Re: **Winsome Filing No. 3 PCM Certification Letter**  
**El Paso County, Colorado**

This letter serves as the certification for Winsome Filing No. 3, El Paso County, CO consistent with El Paso County Engineering Manual ("ECM") Section 5.10.6.B, which states that Engineering Record Drawings shall be accompanied by a certification letter from the Engineer of Record which shall state that facilities constructed provide the required storage volume, meet the required release rates, the stage areas, elevations and outlet dimensions. Based upon this information and information gathered during periodic site visits to the site during significant/key phases of the infrastructure installation, Kimley-Horn & Associates, Inc. is of the opinion that the work performed under the County Permit, per Section 5.10.6.B of the ECM, have been constructed in general compliance with the approved Construction Plans as filed with the County dated April 28, 2023 and approved by El Paso County on May 31, 2023.

# V1\_PCM Certification Letter and Revised MHFD Calcs (ASB).pdf

### 12 ROCK CHUTE #4 PROFILE- CROSS SECTION 2

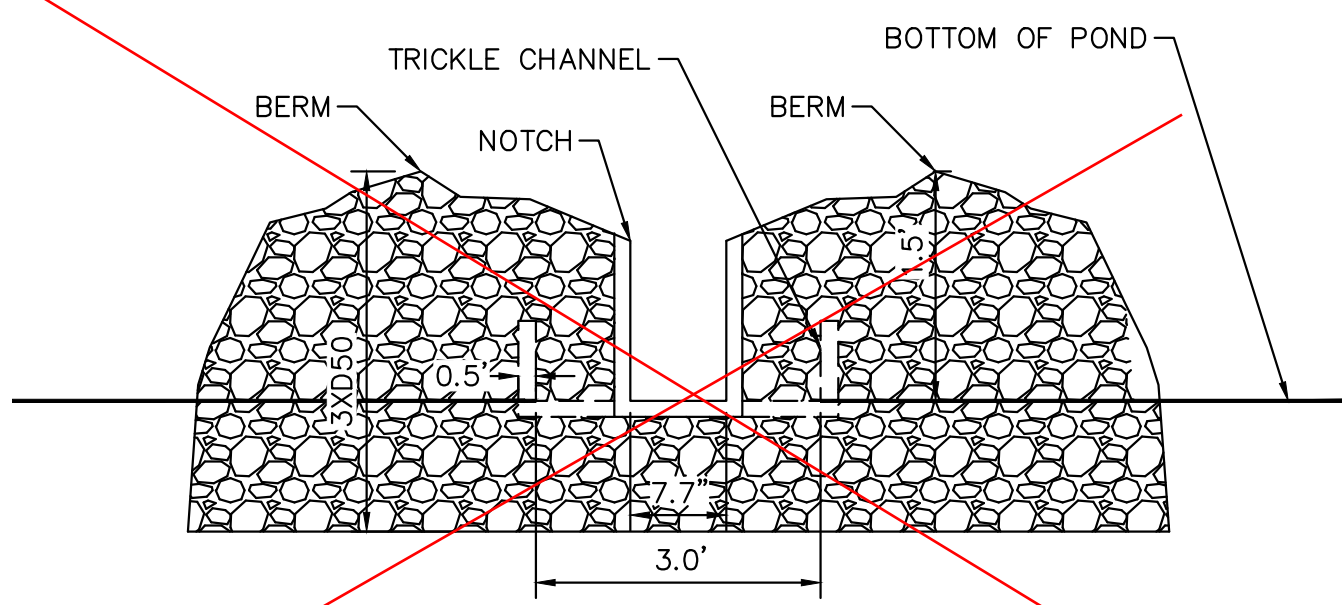
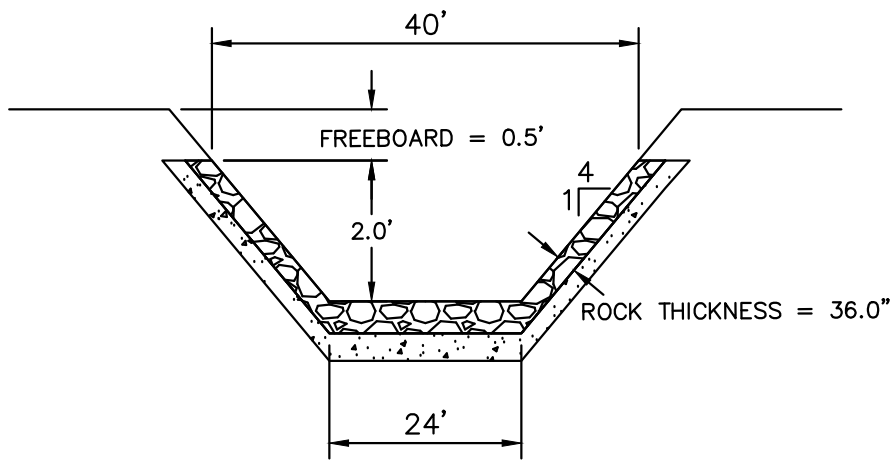
Provide detail for PVC  
pipe to trickle channel

NOTCH REPLACED  
WITH PVC PIPE PER  
FIELD CHANGE.  
VERIFIED WITH EPC  
STORMWATER PIROW  
TO FIELD CHANGE

10 **ROCK CHUTE #12 PROFILE- CROSS SECTION 2**  
N.T.S.

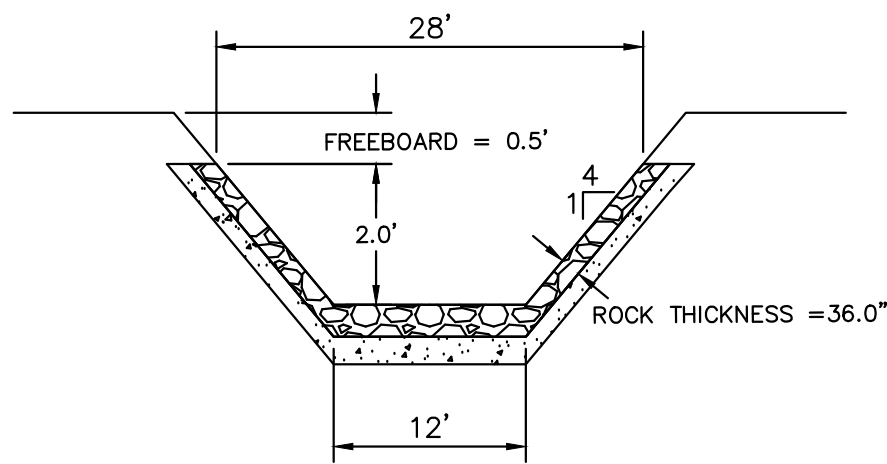
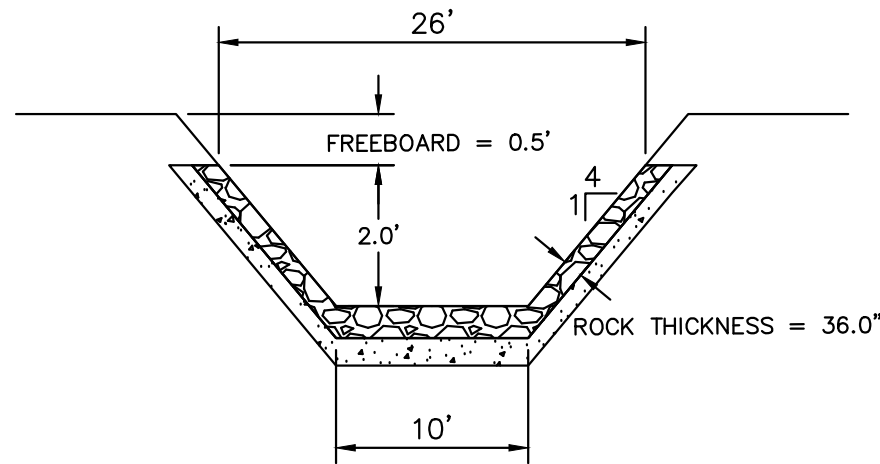
Provide detail for PVC pipe to trickle channel

NOTCH REPLACED WITH PVC PIPE PER FIELD CHANGE. VERIFIED WITH EPC STORMWATER PIROW TO FIELD CHANGE

# DETENTION BASIN STAGE-STORAGE TABLE BUILDER

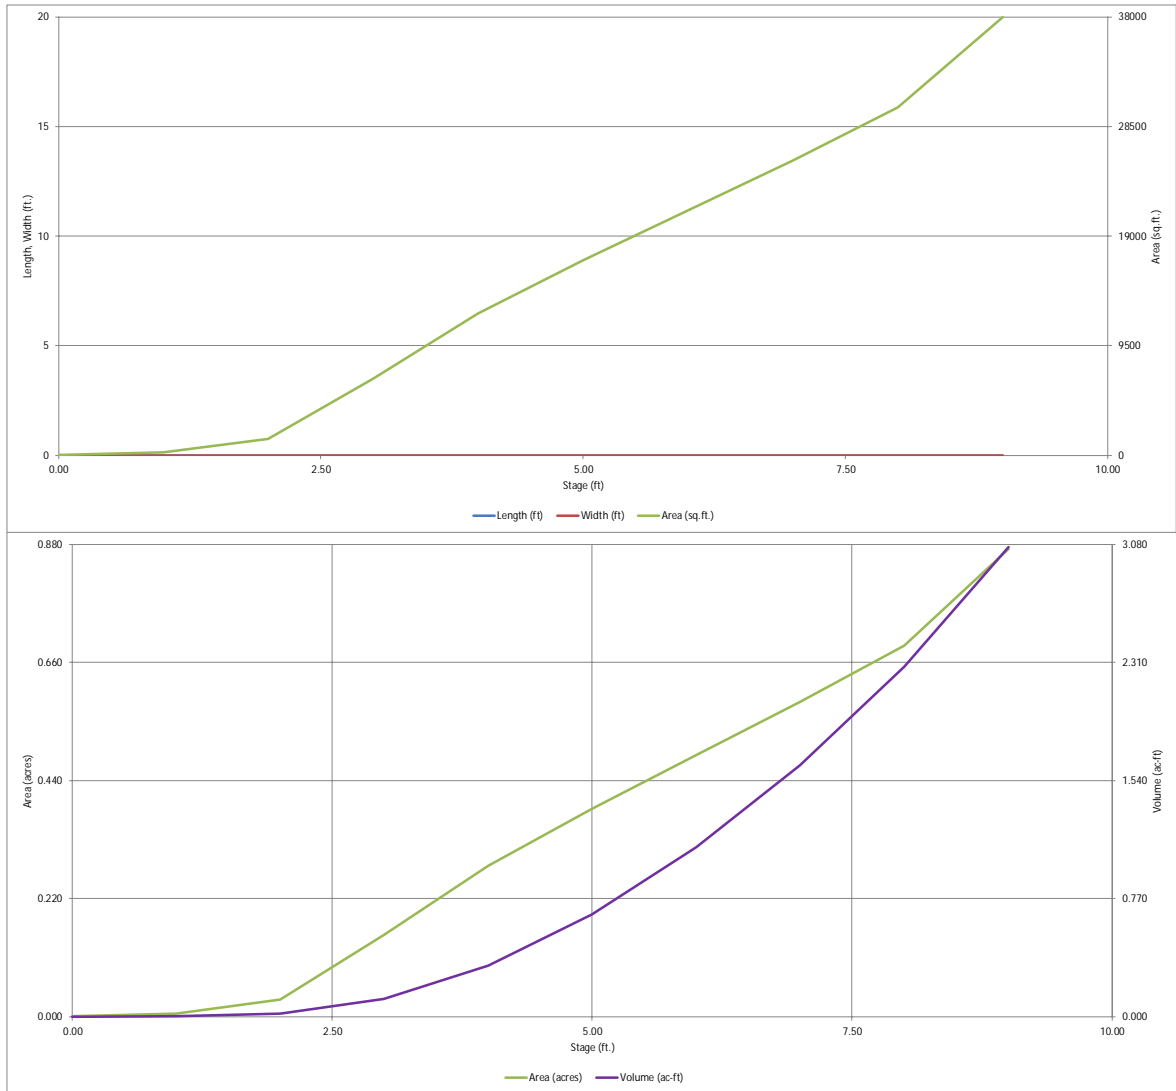
All orange-shaded spreadsheet values do not match as-built drawings. Revise to match.

# DETENTION BASIN OUTLET STRUCTURE DESIGN

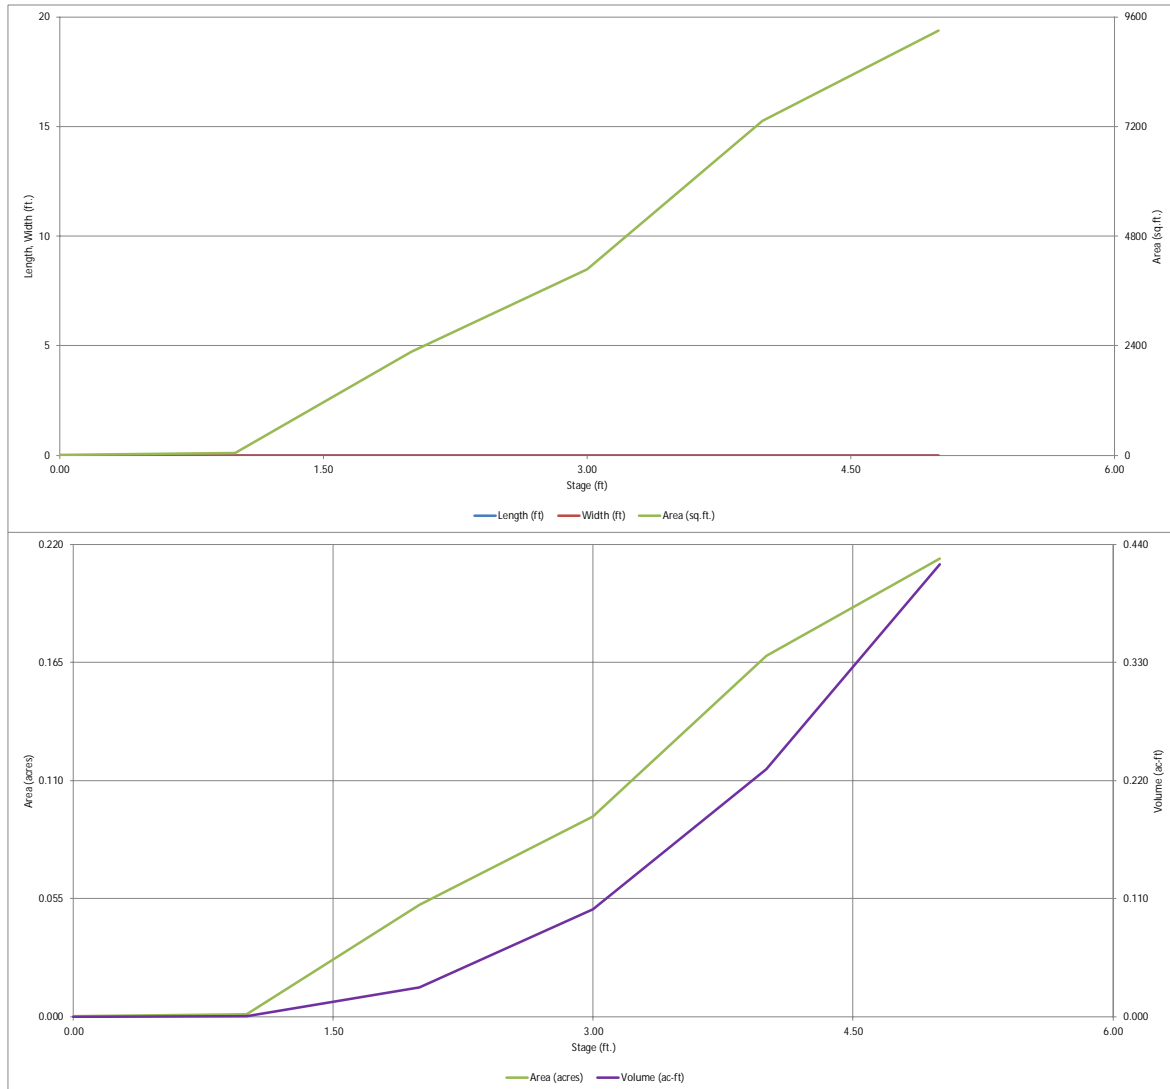
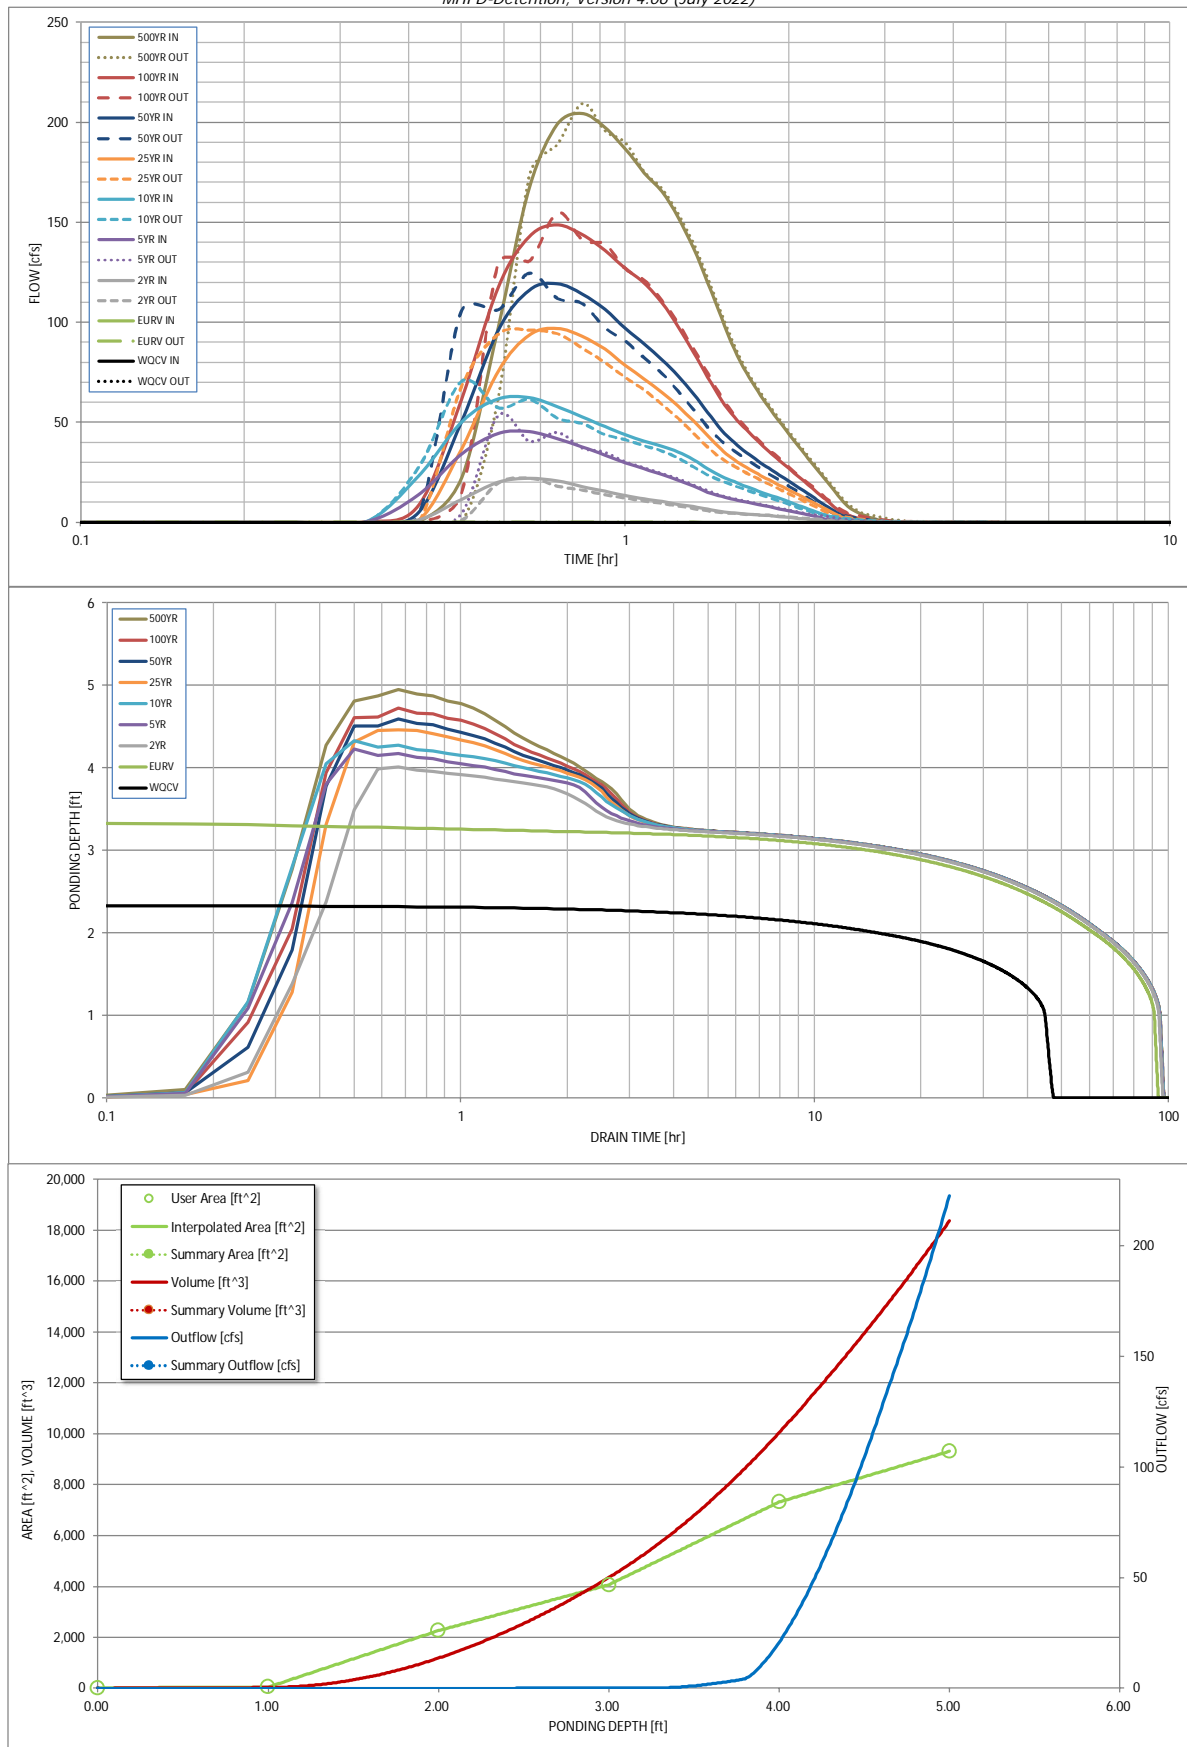
Q5 is higher than design conditions. Suggest adding a restrictor plate to reduce peak outflow.
